Access Compliance Report

Public Rights-of-Way

Intersection ID: 6579	Main Street: MINERAL_SPRINGS_RD	Cross Street: CENTURY_OAKS_LN	Location: NW
ADA ID: 878B2A7A9F4F	Ramp Type: BlendTrans1	Initial Pass/Fail: Fail	Overall Compliance: No
		Severity Score: 1.25

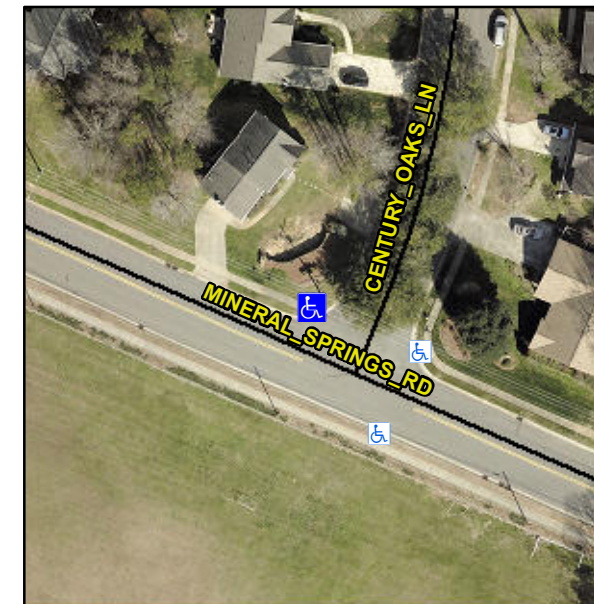
Not Found, R304.5.3

Compliance	Description	Data	Compliance	Description	Data
N/A	Ramp Length (in)	23.0	Yes	BlendTrans Slope (%)	4.6
Yes	Ramp Width (in)	62.0	No	BlendTrans XSlope (%)	3.7
N/A	Flare Type LT	N/A	N/A	Flare Type RT	N/A
N/A	Flare Slope LT (%)	N/A	N/A	Flare Slope RT (%)	N/A
N/A	Flare Traversable LT?	N/A	N/A	Flare Traversable RT?	N/A
N/A	Landing Length (in)	N/A	N/A	DWS Provided?	N/A
N/A	Landing Width (in)	N/A	N/A	DWS Contrast?	N/A
N/A	Landing Slope (%)	N/A	N/A	DWS Length (in)	N/A
N/A	Landing X Slope (%)	N/A	N/A	DWS Full Width?	N/A
N/A	Landing Curb? (Y/N)	N/A	N/A	DWS Offset (in)	N/A
N/A	Shared Landing?	N/A			
N/A	Gutter Ponding?	N/A	N/A	Gutter Slope (%)	N/A
N/A	Gutter Lip Ht (in)	N/A	N/A	Gutter X Slope (%)	N/A
N/A	Painted X Walk1?	No	N/A	Painted X Walk2?	N/A
	X Walk 1 Direction	To SE		X Walk 2 Direction	N/A
	X Walk 1 Width (in)	N/A		X Walk 2 Width (in)	N/A
	X Walk 1 Slope (%)	0.2		X Walk 2 Slope (%)	N/A
	X Walk 1 X Slope (%)	2.1		X Walk 2 X Slope (%)	N/A

N/A	Ramp inside XWalk1?	N/A	N/A	Ramp inside XWalk2?	N/A
	Road Slope (%)	2.1		Clear Space?	N/A
	Road X Slope (%)	0.2	N/A	Clear Space to XWalk (in)	N/A
N/A	Any Obstructions?	N/A	N/A	Storm Grate/Utility Hazard?	N/A
	Obstruction Type			Storm Grate/Utility Type	
		N/A			N/A
			Yes	Surface Condition? (G/P)	Good
			No	Curb Slope (%)	10.4

Remove & Replace Curb Ramp With Two New Directional Ramps or Equivalent.
